1-**A/ 3-**A Copper Faucet Riser - One-Piece with Insert

Shop Drawing Submittal Review

Project Name: Webster University-**ISB**

SPEC SECTION: 22 4216.16
Commercial Sinks

SK-3 SINK

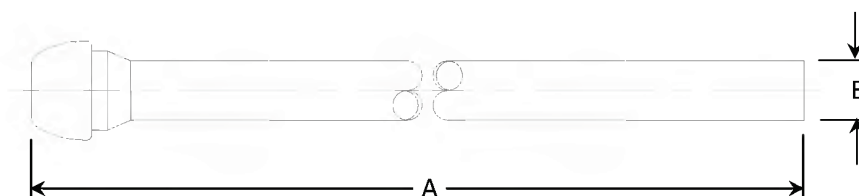
S/S SINK BASKET STRAINER W/ 1-1/2" CP BRASS TAILPIECE
1-1/2 SEMI CAST P TRAP W/CO CP
LF 1/2" NOM COMP X 3/8" OD COMP W/ LOOSE KEY
12" X 3/8" OD LAVATORY SUPPLY LINE
5/8" OD CP SHALLOW ESC FLANGE
~~COVER FOR TRAP / HOT & COLD STOP & SUPPLY~~
~~LEAD LAW COMPLIANT 3/8 THERMOSTAT TEMPERING VALVE~~

1. Sink is integral with the counter-top. Coordinate with the architectural drawings.
2. Provide under counter waste and supply protective piping covers as required.
Verify requirements with the architectural drawings.
3. Escutcheons are specified to be cast brass. Refer to specification section 220518.
